Planning stage structural report

150 Day Street

Prepared for UOL / 20th March 2025

Issue: Revision 2

1 BASEMENT B01 PLAN
RS_020 1:200

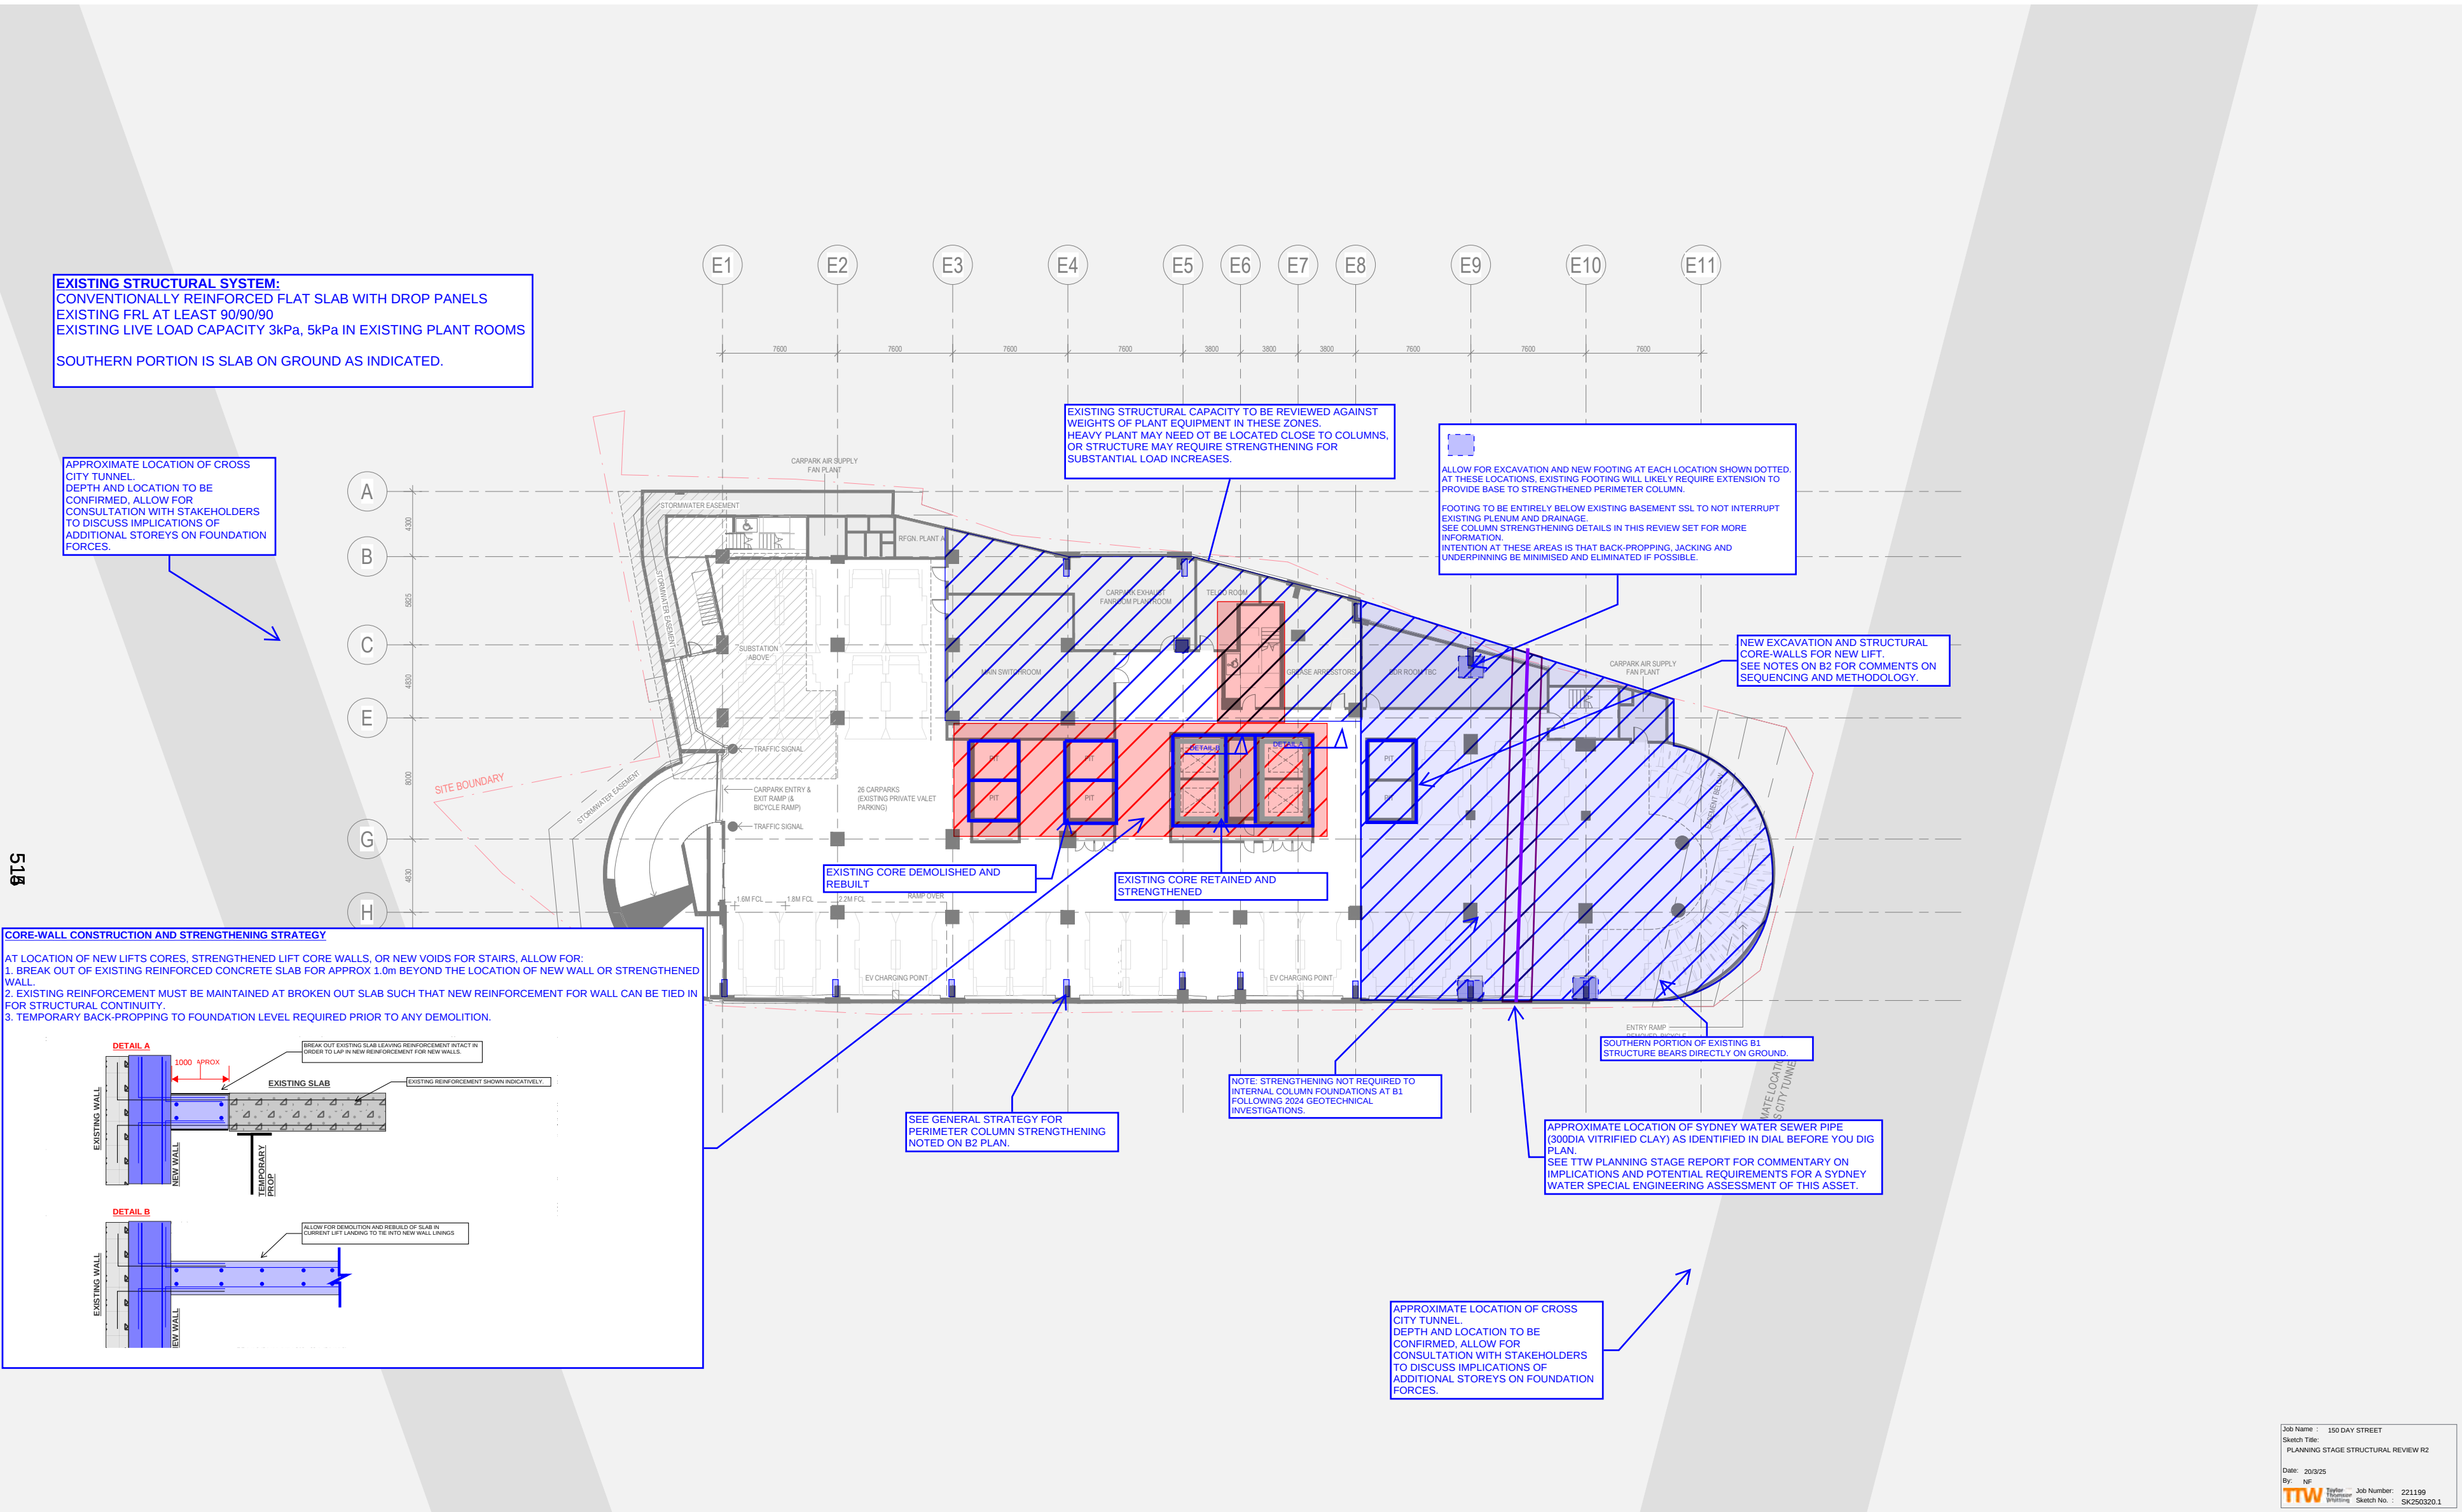
EXISTING STRUCTURAL SYSTEM:
CONVENTIONALLY REINFORCED CONCRETE SLAB ON GROUND

APPROXIMATE LOCATION OF GEOTECHNICAL
FAULT ZONE THROUGH SITE, WITH LOWER
ALLOWABLE BEARING CAPACITY

APPROXIMATE LOCATION OF CROSS
CITY TUNNEL.
DEPTH AND LOCATION TO BE
CONFIRMED, ALLOW FOR
CONSULTATION WITH STAKEHOLDERS
TO DISCUSS IMPLICATIONS OF
ADDITIONAL STOREYS ON FOUNDATION
FORCES.

INTERNAL FOUNDATION STRENGTHENING STRATEGY

ALLOW FOR EXCAVATION AND NEW FOOTING AT EACH LOCATION SHOWN DOTTED.
AT THESE LOCATIONS, EXISTING FOOTING WILL LIKELY REQUIRE EXTENSION TO
PROVIDE BASE TO STRENGTHENED PERIMETER COLUMN.

FOOTING TO BE ENTIRELY BELOW EXISTING BASEMENT SSL TO NOT INTERRUPT
EXISTING PLENUM AND DRAINAGE.
SEE COLUMN STRENGTHENING DETAILS IN THIS REVIEW SET FOR MORE
INFORMATION.
INTENTION AT THESE AREAS IS THAT BACK-PROPPING, JACKING AND
UNDERPINNING BE MINIMISED AND ELIMINATED IF POSSIBLE.

EXISTING LIFT CORE TO BE STRENGTHENED
BY WRAPPING WITH 350 THICK CONCRETE.
FOOTING STRENGTHENING VIA
UNDERPINNING SHOULD BE ALLOWED FOR AT
EXISTING LIFT LOCATION.

ALLOW FOR CONCRETE JACKETING OF 150mm ON EACH SIDE.

ALLOW FOR INTERNAL RETURN COLUMN ON INSIDE FACE. NEW LOADS FROM
ADDITIONAL STOREYS TO LOAD DIRECTLY INTO THESE EXTENSIONS.
PLAN GEOMETRY OF STRENGTHENED SECTION MAY BE MODIFIED, AT TYPICAL
HOTEL FLOOR INTENTION IS FOR COLUMN TO FIT WITHIN HOTEL WALL.

1 L03 PLAN
RS_020 1:200

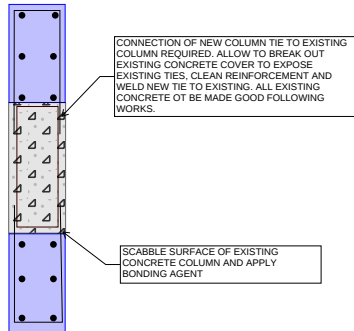
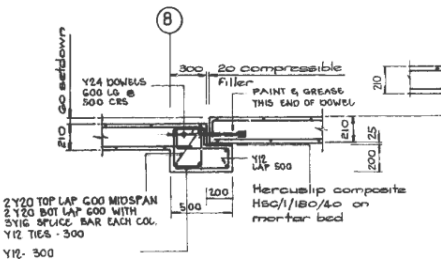
EXISTING FIRE STAIR AND ATRIUM VOID IN
FILLED WITH STRUCTURAL STEEL BEAMS AND
BONDEK IN ARRANGEMENT SHOWN.

GENERAL SOLUTION TO INFILL EXISTING
STAIR VOIDS WITH BONDEK AND
STRUCTURAL STEEL FRAMING.

SEE NOTE ON LEVEL 2 PLAN REGARDING
WHAT WOULD BE REQUIRED IN TERMS
OF BUILDING A NEW TRANSFER BEAM
TO REMOVE COLUMN AT L2.

PERIMETER COLUMN STRENGTHENING
GENERAL INTENT OF WORKS AS PER NOTES ON B2 SHEET OF THIS SET.

THERE IS AN EXITING BUILDING JOINT AT GRID 8 WHICH STRUCTURALLY SEPARATES
THE STRUCTURE TO THE NORTH AND SOUTH OF THIS LINE FROM THE BASE TO THE
TOP OF THE EXISTING STRUCTURE.
STEEL PLATES WILL BE USED TO TIE TOGETHER THE STRUCTURE ACROSS THIS
JOINT AT ALL FLOORS SO THAT THE BUILDING BEHAVES ROBUSTLY AS A SINGLE
STRUCTURAL ELEMENT.

1 L04 PLAN
RS_020 1:200

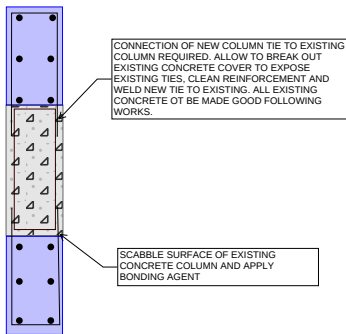
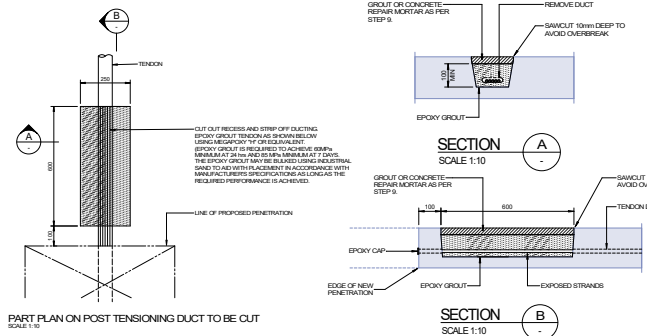
EXISTING STRUCTURAL SYSTEM:
POST-TENSIONED CONCRETE STRUCTURE
EXISTING FRL AT LEAST 90/90/90
EXISTING LIVE LOAD CAPACITY LIVE LOAD- 2kPa
SUPERIMPOSED DEAD LOAD- 2kPa (PARTITIONS)

EXISTING FIRE STAIR AND ATRIUM VOID IN FILLED WITH STRUCTURAL STEEL BEAMS AND BONDEK IN ARRANGEMENT SHOWN.

PERIMETER COLUMN STRENGTHENING
GENERAL INTENT OF WORKS AS PER NOTES ON B2 SHEET OF THIS SET.

NOTE ON REQUIREMENTS FOR TRUNCATING EXISTING POST-TENSIONING.

FOR NEW LIFT AND STAIR SOUTH OF GRID E8 IN PARTICULAR.

TRUNCATION OF EXISTING POST-TENSIONING WILL BE REQUIRED TO FORM NEW OPENING FOR LIFT AND STAIR VOID. DETAILED ANALYSIS REQUIRED AT NEXT DESIGN STAGE IN ORDER TO ASSESS ANY ADDITIONAL STRENGTHENING IN ADJACENT SLAB WHICH MAY BE REQUIRED TO FACILITATE THIS TRUNCATION.

3. For each tendon to be cut, carefully remove a 600 long by 250 wide strip of concrete from above and around the tendon 50mm from the penetration. DO NOT CUT ANY REINFORCEMENT. Strip off the slabs and clean out the existing grout.

7. Cut the slab into manageable chunks and remove them.
8. Remove the platform and props.
9. Fill top portion of strip with 21 sand cement grout or Rendicrete HF for internal applications and Rendicrete HB40 Plus for external applications or areas with no applied finishes. Fill in to be finished slab with surrounding concrete surface.

1 L11 PLAN - TRANSFER FLOOR

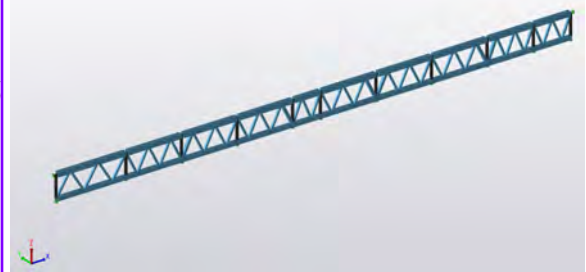
ALLOW FOR STRENGTHENING TO EXISTING L11 STRUCTURE TO FACILITATE CHANGE OF USE. STRENGTHENING MAY BE ACHIEVED BY A GRILLAGE OF BEAMS ABOVE THE EXISTING SLAB (HIDDEN WITHIN AN ACCESS FLOOR) TO SUPPORT THE WEIGHTS OF PLANT, LANDSCAPE AND POOL LOADS.
THIS STRENGTHENING COULD BE INCORPORATED INTO A CONSTRUCTION CRASH DECK WHICH WOULD BE INSTALLED TO ALLOW FOR CONSTRUCTION OF THE ADDITIONAL STOREYS WHILE ACCESS IS MAINTAINED BELOW FOR MODIFICATION AND FIT-OUT WORKS,
EXISTING CONCRETE TOPPINGS MUST BE REMOVED FROM THIS SLAB TO MINIMISE EXISTING WEIGHT PRIOR TO NEW WORKS TAKING PLACE.
RENOVATION WORKS IN THE 1990s INCLUDED ADDITION OF NEW TOPPINGS WHICH HAVE REDUCED AVAILABLE STRUCTURAL CAPACITY BELOW ORIGINAL DESIGN INTENT.

EXISTING STRUCTURAL SYSTEM:
POST-TENSIONED CONCRETE STRUCTURE
EXISTING FRL AT LEAST 90/90/90
EXISTING LIVE LOAD CAPACITY LIVE LOAD- 3kPa TYPICALLY, 7.5kPa IN EXISTING PLANT-ROOM.

NOTE ON HEAVY PLANT EQUIPMENT
HEAVY PLANT WILL REQUIRE STEEL GRILLAGE AT LOW LEVEL FOR STRUCTURAL SUPPORT IN ORDER NOT TO OVERLOAD EXISTING SLAB.
GENERAL INTENTION IS TO PROVE AND ACCESS FLOOR OVER LOW-LEVEL STEEL BEAM GRILLAGES.
STRUCTURAL REVIEW ON EIGHTS OF PLANT, INCLUDING PLINTHS, MUST BE CARRIED OUT TO EXISTING STRUCTURE IS NOT OVERLOADED.
HEAVY PLANT SHOULD BE LOCATED CLOSE TO STRUCTURAL SUPPORTS (COLUMNS) AND LIGHT-WEIGHT PLINTHS SPECIFIED TO MINIMISE STRENGTHENING REQUIREMENTS.

AT BUILDING PERIMETER, COLUMN TRANSFER COULD BE ACHIEVED BY TRUSSES, OR BY DEEP STRUCTURE, POTENTIALLY HIDDEN WITHIN THE DEPTH OF THE PROPOSED PLANTER BEDS.
ALLOW FOR 1200WB455 TO TRANSFER LOADS FOR INDICATIVE COSTING.

STRUCTURAL REQUIREMENTS TO SUPPORT WEIGHT OF POOL PLANT MUST BE REVIEWED IN DETAIL WITH INPUT FROM A POOL CONSULTANT.
IN GENERAL, WE WOULD EXPECT THAT A POOL CONSULTANT BE ENGAGED IN ORDER TO PROVIDE SPECIALIST ADVICE REGARDING PLANT, SPATIAL LAYOUTS AND REQUIREMENTS FOR BALANCE TANKS.

GENERAL STRUCTURAL SOLUTION TO PROVIDE FULL STOREY STEEL TRUSSES TO TRANSFER COLUMN LOADS AT THIS STOREY.
TRUSSES TO BE ARRANGED IN NORTH-SOUTH ORIENTATION OVER EXISTING COLUMN GRID LOCATIONS AS INDICATED.
LOWER STEEL-TONNAGE SOLUTIONS WILL BE ACHIEVED WITH IRREGULAR WARREN TRUSSES WHICH DIRECTLY TRANSFER COLUMN LOADS BY DIAGONALS AT EXACT REQUIRED LOCATIONS.
NOMINALLY, AN IRREGULAR TRUSS WITH OPTIMISED GEOMETRY WILL REQUIRE APPROXIMATELY HALF THE STEEL TONNAGE OF A REGULAR TRUSS.
OPTION 1: OPTIMISED IRREGULAR TRUSS
TOTAL STEEL WEIGHT FOR COSTING, APPROXIMATELY 450kg/m

OPTION 2: NON-OPTIMISED REGULAR TRUSS
TOTAL STEEL WEIGHT FOR COSTING, APPROXIMATELY 1100kg/m

NOTE ON PROPOSED USE OF GYM AREA
GENERALLY ALLOW FOR SUB-FLOOR OR ACCESS FLOOR WITHIN GYM AREA TO MINIMISE IMPACT OF VIBRATION PROPAGATION THROUGH STRUCTURE.
SOME DEGREE OF STRUCTURAL STRENGTHENING LIKELY REQUIRED IN GYM AREA IN ORDER TO INCREASE EXISTING CAPACITY TO REQUIRED LEVEL. EXTENT OF STRENGTHENING TO BE ADVISED FOLLOWING DETAILED INVESTIGATION OF EXISTING CAPACITY AND WEIGHTS OF EXISTING FINISHES.

NOTE ON DEEP PLANTER ZONE AND INTEGRATED TEMPORARY WORKS DECK AT L11
INCLUSION OF DEEP PLANTER ZONE AT L11 WILL REQUIRE EXTENSIVE STRENGTHENING OF EXISTING STRUCTURE DUE TO INCREASED WEIGHT.
AS WE WILL BE BUILDING ABOVE THE EXISTING HOTEL FROM THIS FLOOR, THERE WILL BE EFFICIENCIES IN INCORPORATING THIS STRENGTHENING INTO A CRASH-DECK AND CONSTRUCTION PLATFORM WHICH WILL ALLOW FOR SAFE CONSTRUCTION ABOVE THE EXISTING STRUCTURE.

1 L20 PLAN
RS_200 1:200

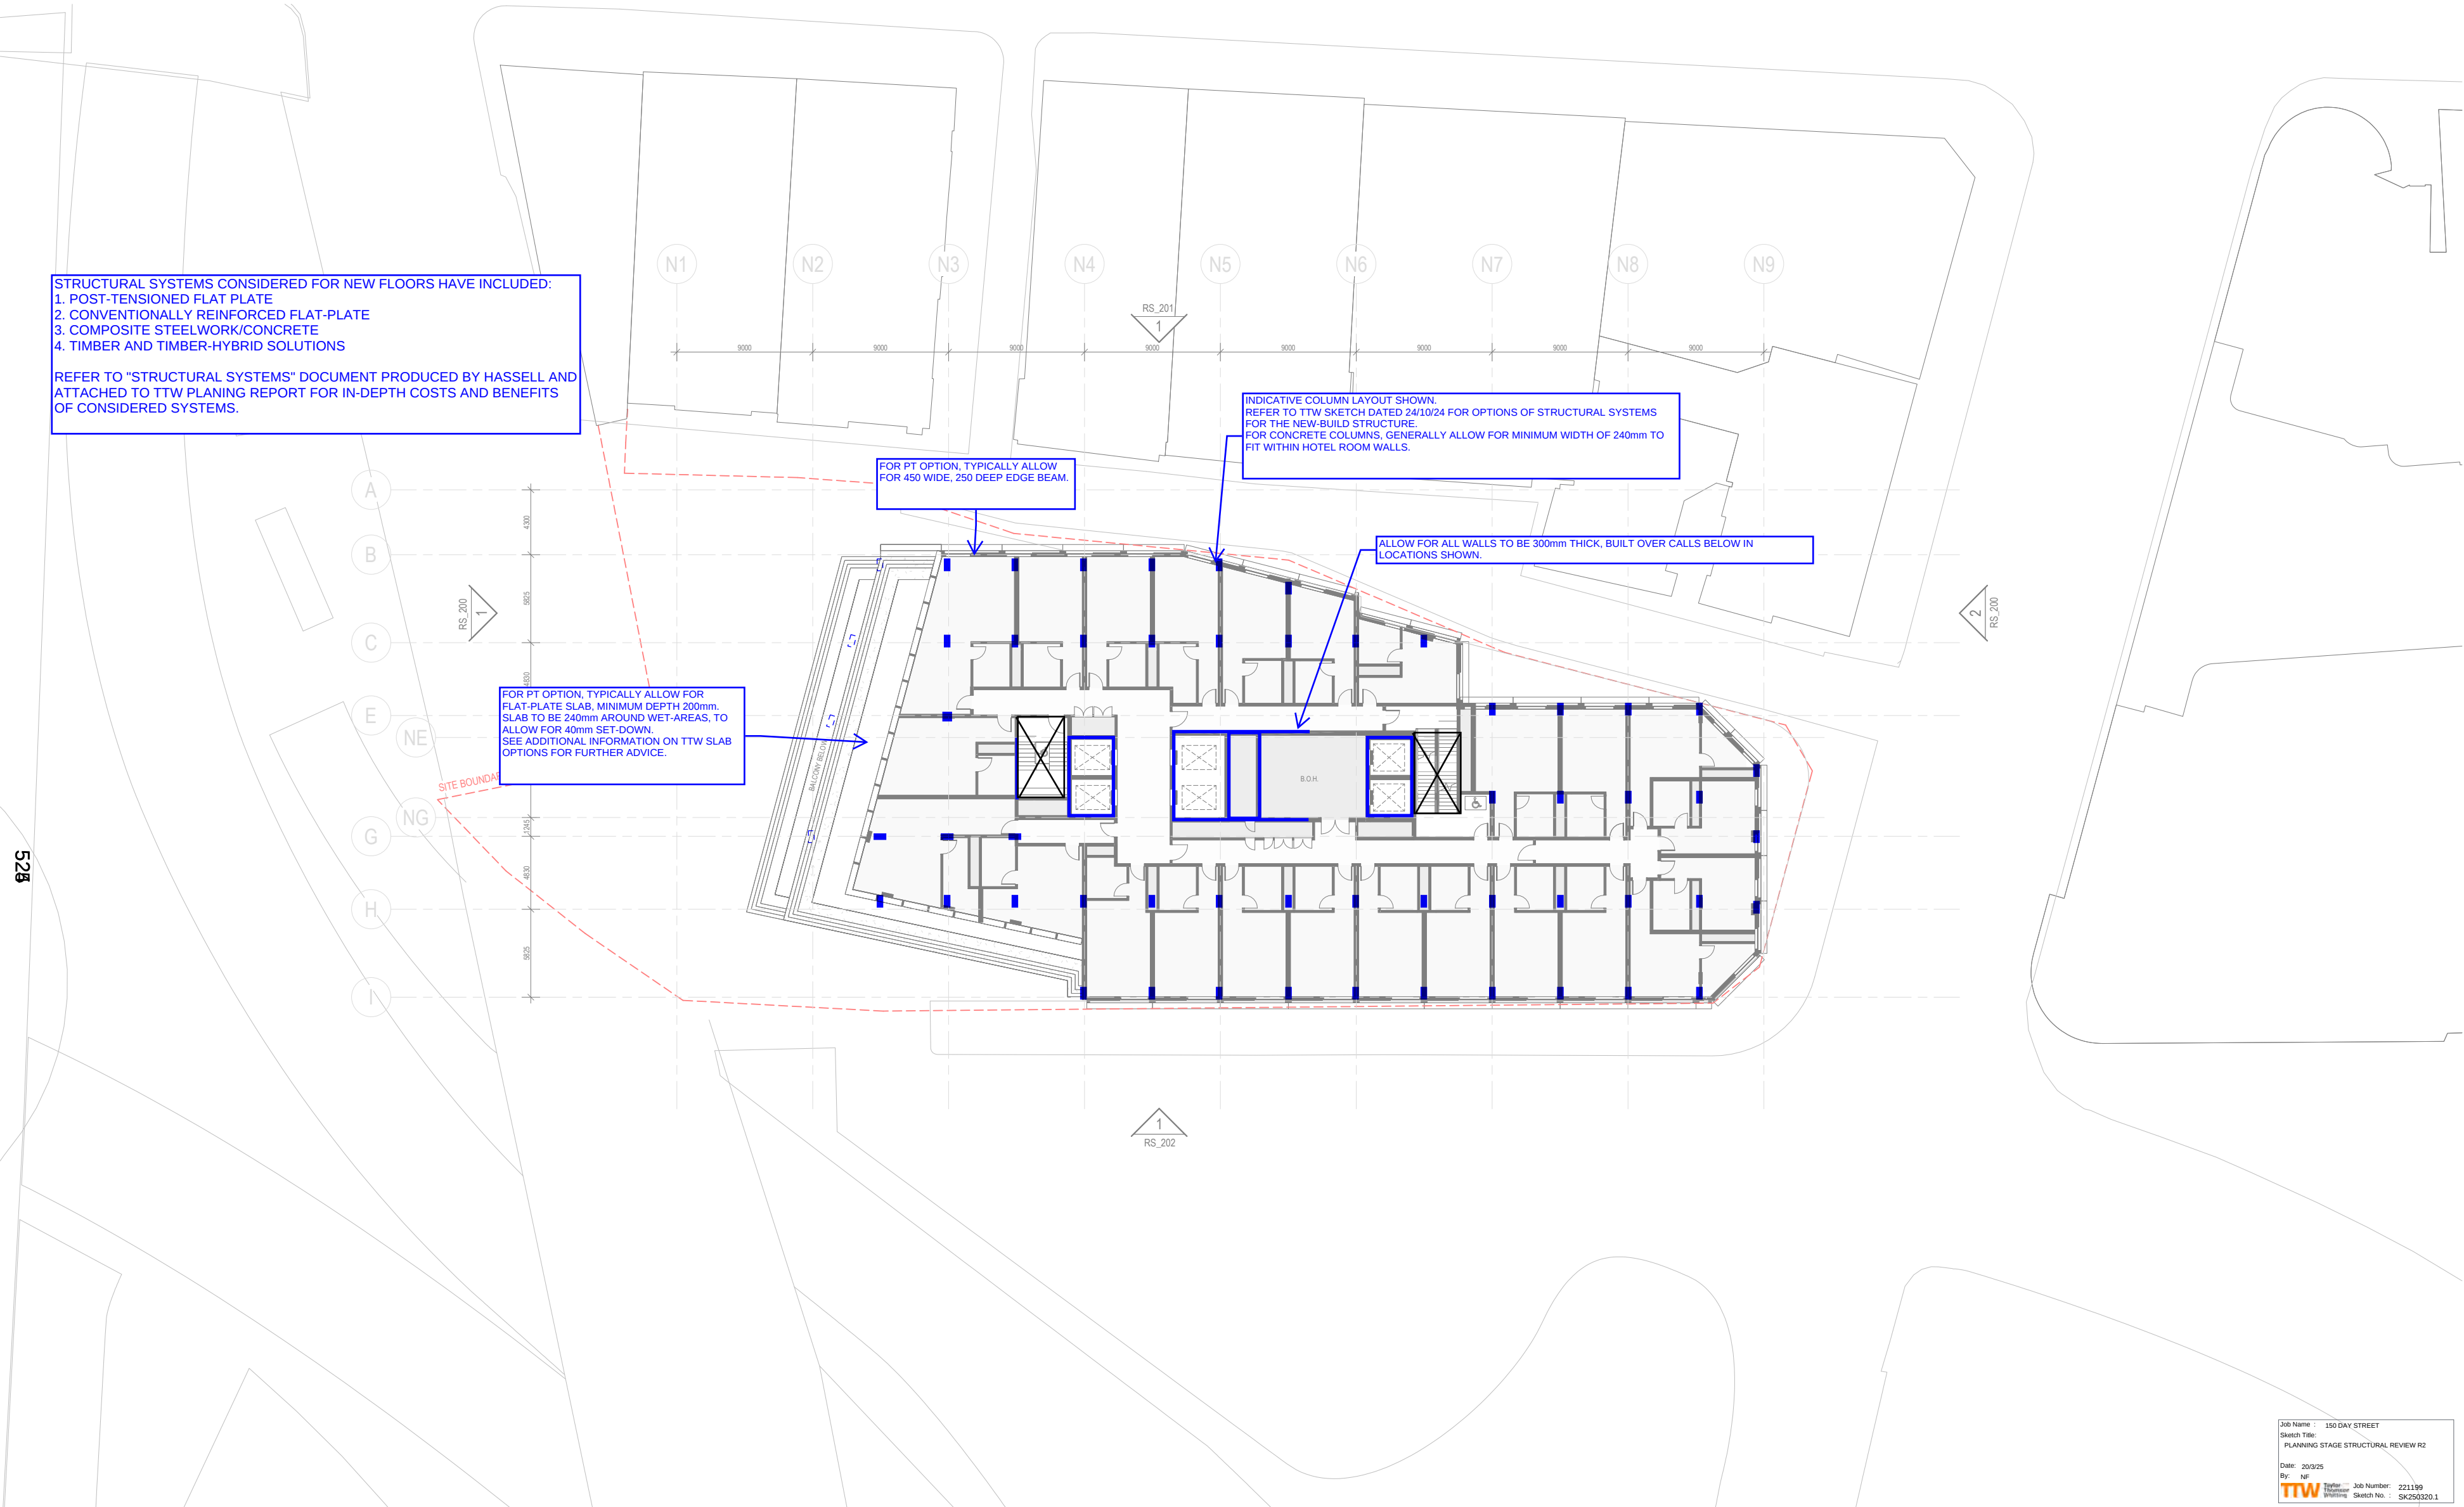
INDICATIVE COLUMN LAYOUT SHOWN.
REFER TO TTW SKETCH DATED 24/10/24 FOR OPTIONS OF STRUCTURAL SYSTEMS FOR THE NEW-BUILD STRUCTURE.
FOR CONCRETE COLUMNS, GENERALLY ALLOW FOR MINIMUM WIDTH OF 240mm TO FIT WITHIN HOTEL ROOM WALLS.

FOR PT OPTION, TYPICALLY ALLOW FOR 450 WIDE, 250 DEEP EDGE BEAM.
